**STAFF REPORT 10-13-2021 REGULAR MEETING**

**APPLICATION NUMBER: 21-7512**

**ADDRESS: 1091 SEMINOLE STREET**

**SCOPE: DEMOLISH EXISTING REAR SIDE PORCH AND ERECT NEW REAR SIDE PORCH; MODIFY EXISTING REAR ADDITION**

2 FLOOR PLAN - EXISTING  
SCALE: 1/4" = 1'-0"

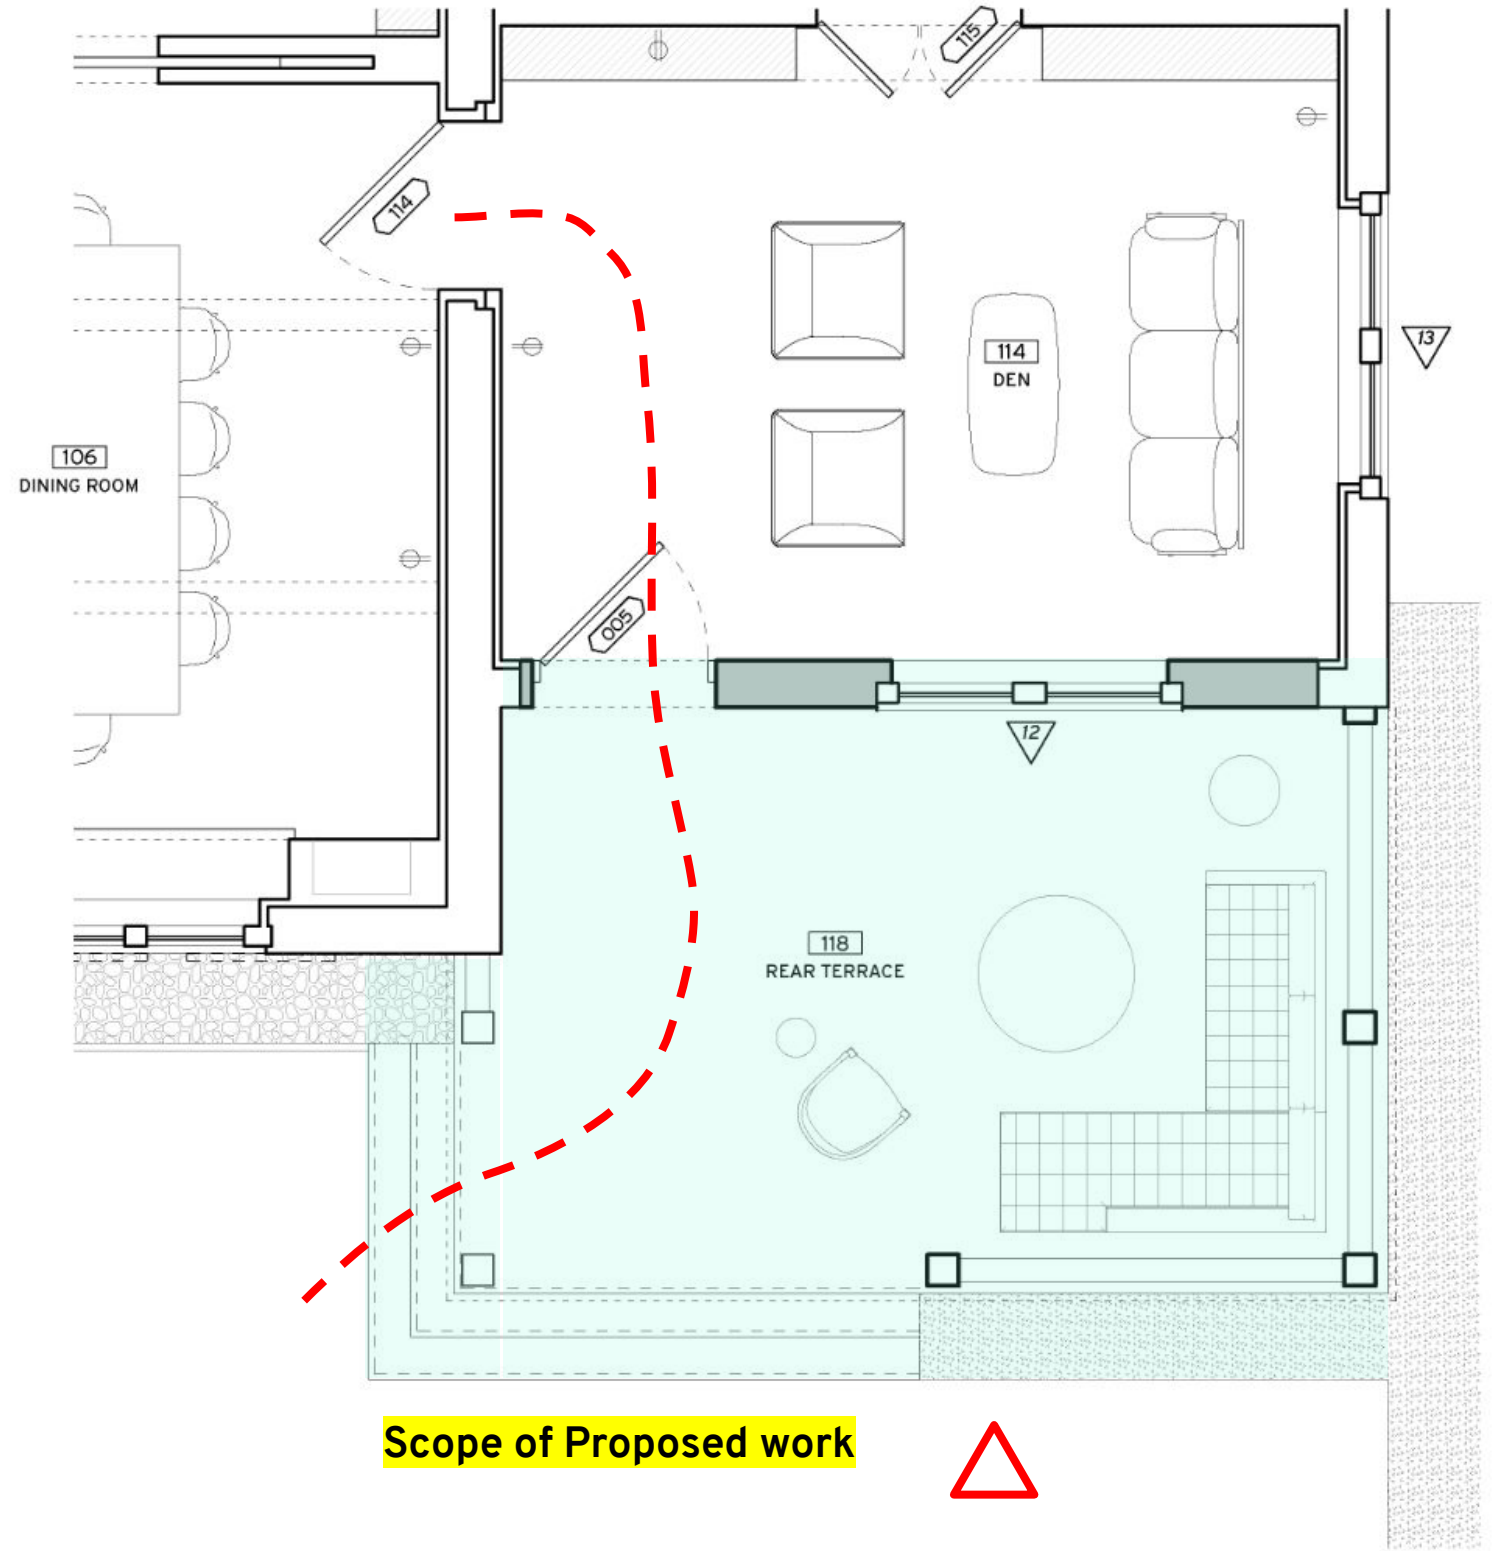
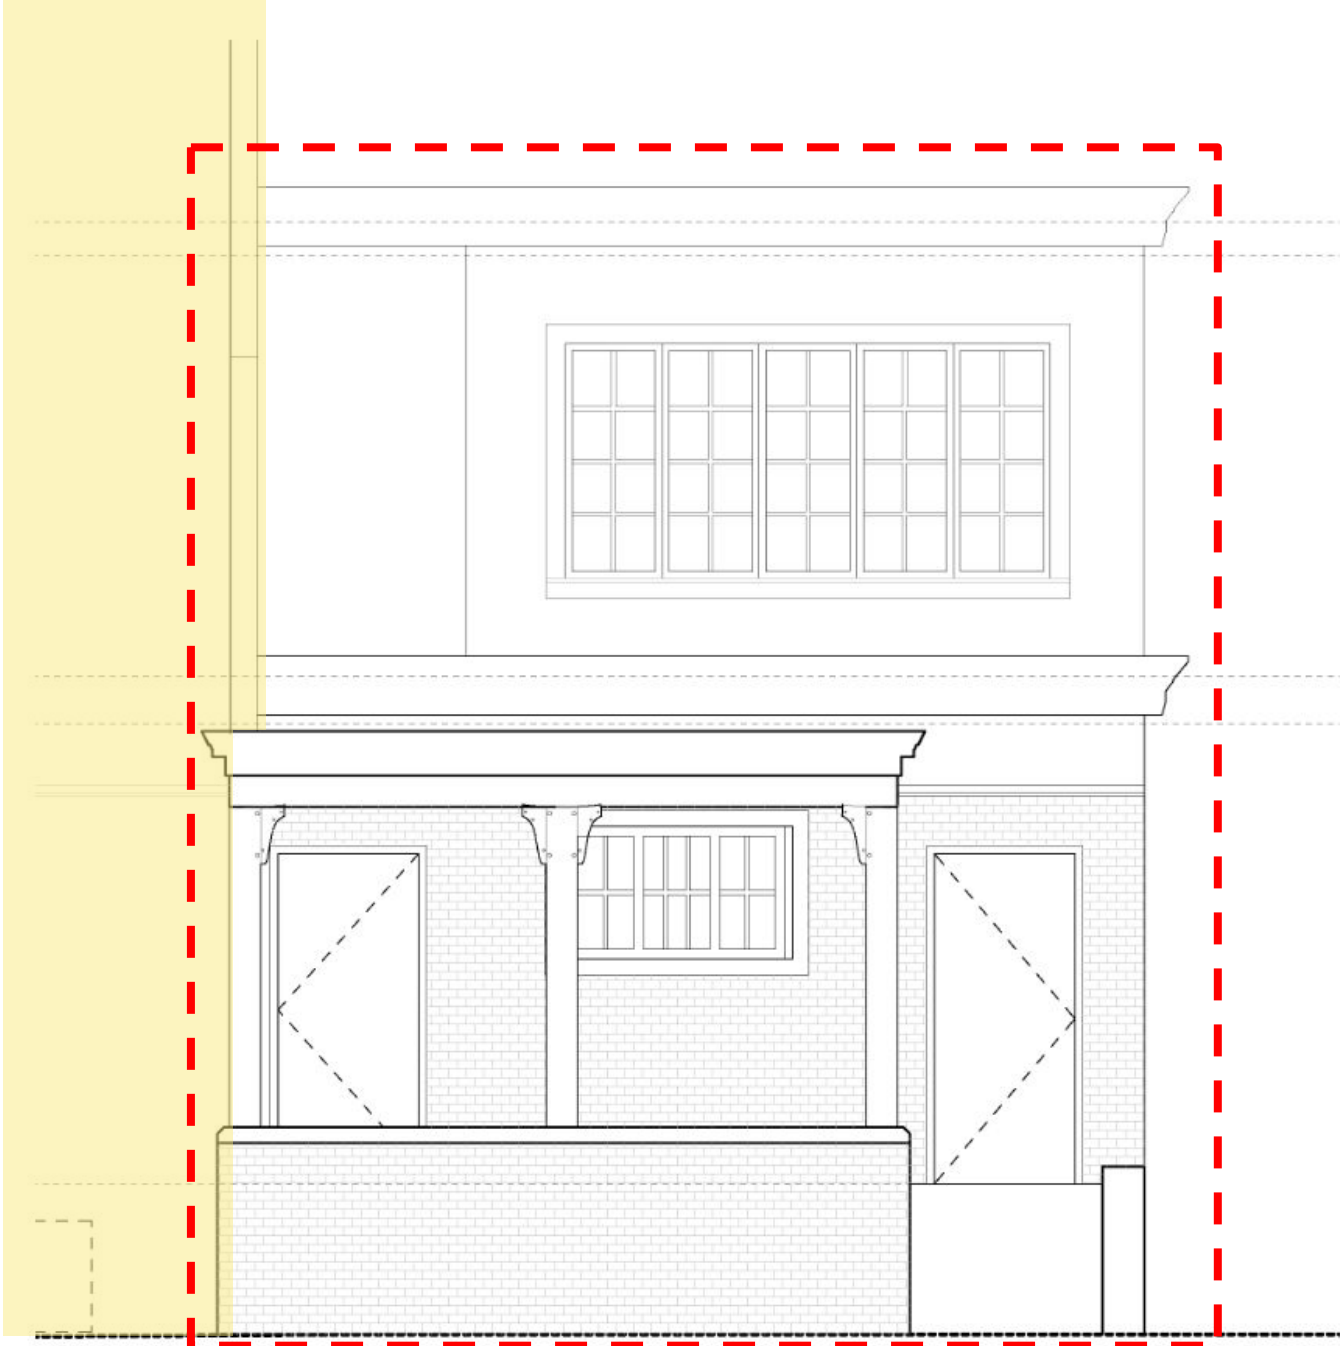
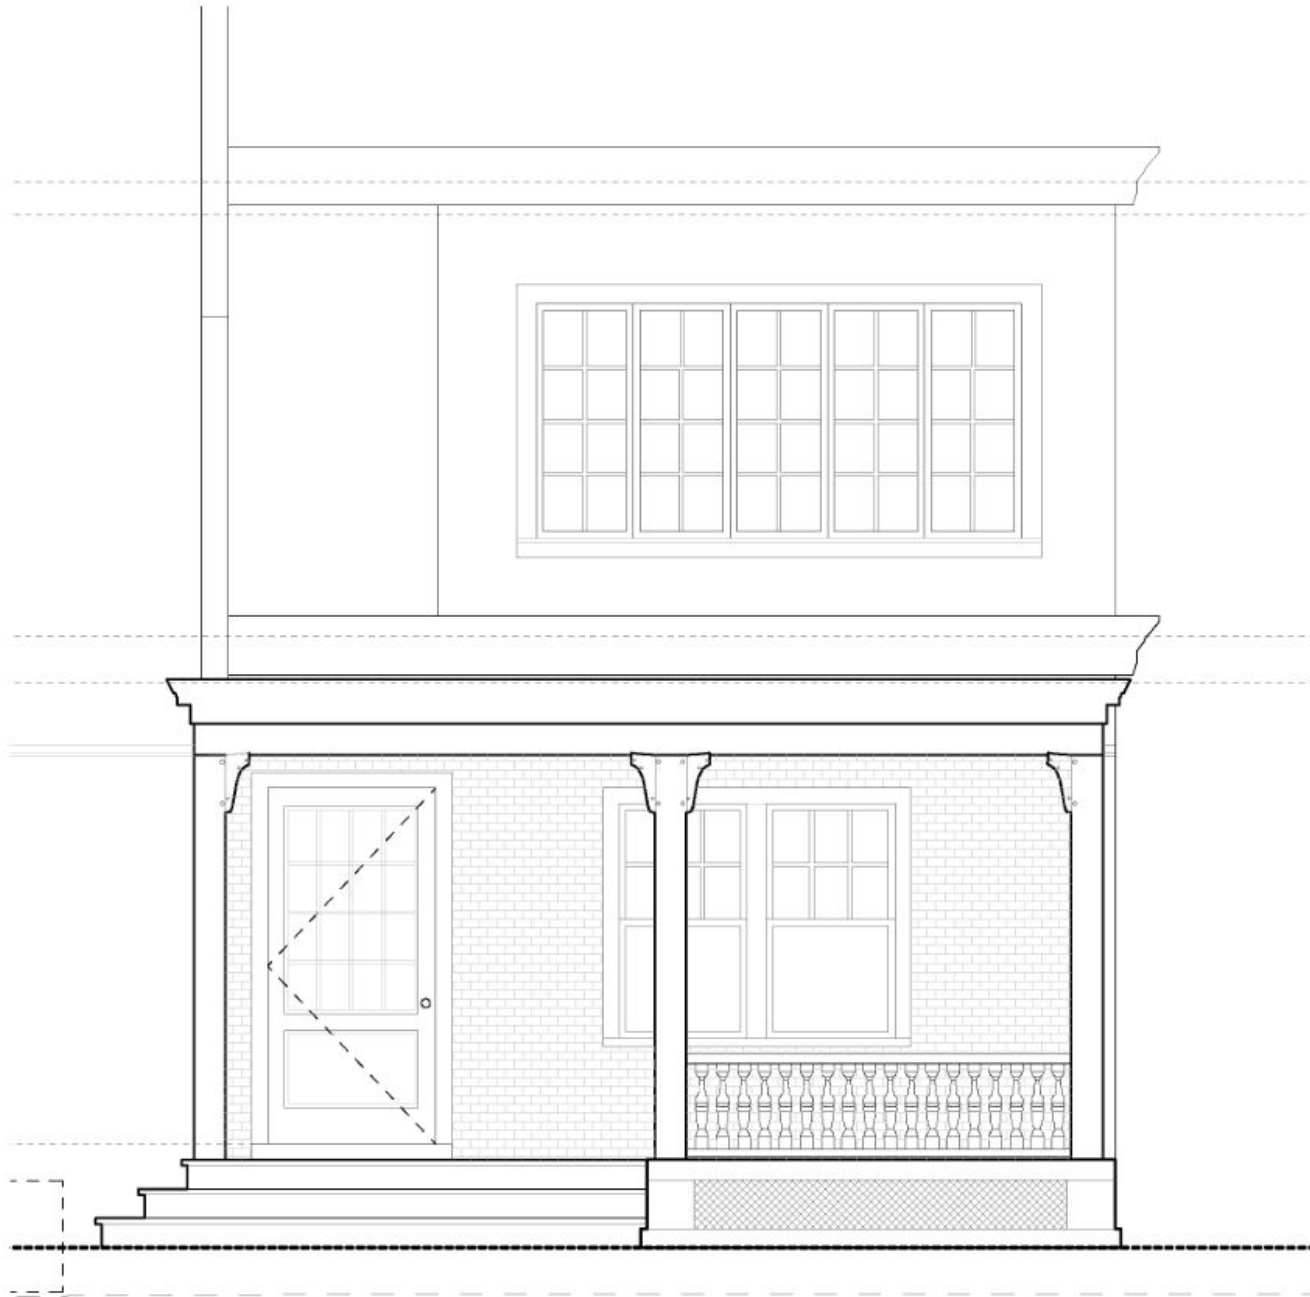
- Staff finds that the demolition of the existing porch and erection of a new porch, as proposed, is in appropriate as it does not meet the Secretary of the Interior’s Standards for Rehabilitation because it removes historic materials and alters spaces which characterize the property.

- Staff finds that the proposal to expand the existing door width and enlarge the height of the window opening at the exterior wall of the house adjacent to the porch inappropriate as it does not meet the Secretary of the Interior’s Standards for Rehabilitation because it alters the space of the character-defining porch and removes the historic character of that space.

It is staff’s opinion that the proposal to demolish the existing historic side rear porch and erection of new porch including the alteration to the existing door and window openings at the exterior wall of the house, as proposed, removes historic materials and alters spaces which characterize the property, and is inappropriate with respect to the character of this property and its environment. Staff therefore recommends that the Commission issue a Denial for the proposed work because it does not meet the Secretary of the Interior’s Standards for Rehabilitation, especially Standards:
